**Subject:** Re Your Reference TR010018

#### Description of Change DR1.08

The realignment of the Mill Common (Lane) in Huntingdon as shown in the drawings in the DCO application, drawing General Arrangement Plan Huntingdon Town Centre Sheet 2 (*applicant reference HE/A14/EX/68 PINS reference REP5-030*), passed through the private car park belonging to Centenary House immediately adjacent to Castle Moat Road, the Huntingdon Ring Road, resulting in the complete loss of the car park.

'Before' extracts from General Arrangement Plans Sheet HT 2 and Land Plans Sheet 34

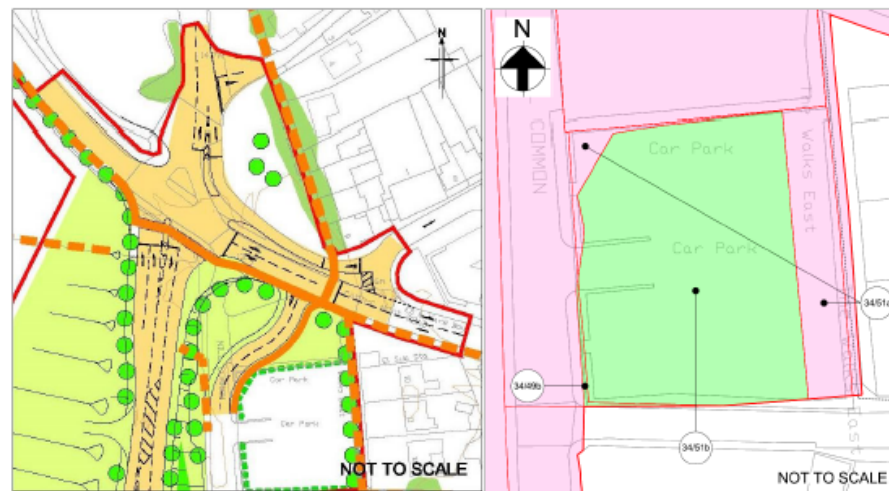
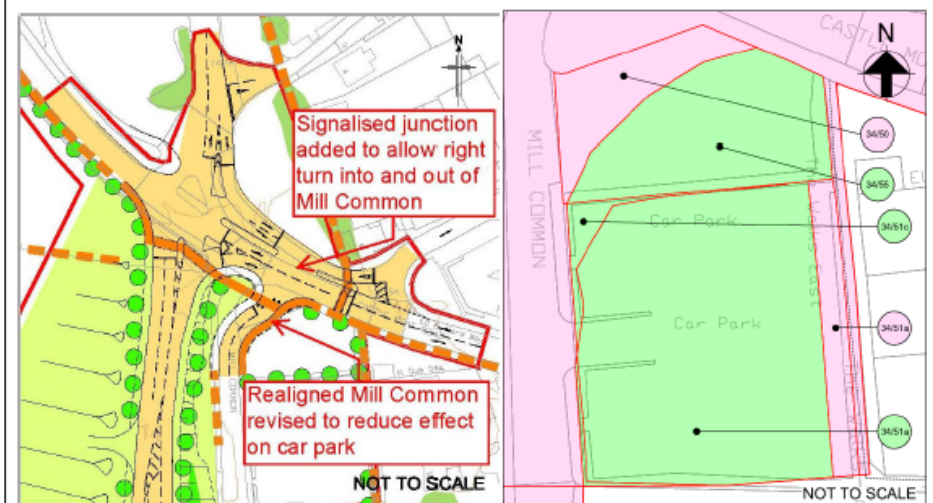
A response to my query was received from John Lewell 6<sup>th</sup> October (copy email attached). This confirms the current change DR1.08 in relation to the land take does show a greater extent of pink than it needs to but that the design/layout drawing shows the correct layout such that the scheme will only take the agreed 4 parking spaces.

In considering the application can you note your files that whilst the General Arrangements Plan can be relied upon an updated Land Plan will need to be submitted by Highways England.

The current change DR1.08 in relation to the landtake does show a greater extent of pink than it needs to. The design/ layout drawing shows the correct layout as we discussed, the detail design stage will resolve the access to the car park.

The scheme does only take the original 4 parking spaces and once the detail design stage is complete the boundary line would sit just behind the proposed footway running adjacent to the realigned Mill Common road. The exact position would be dependent on the detail design and the access arrangements agreed with yourselves.
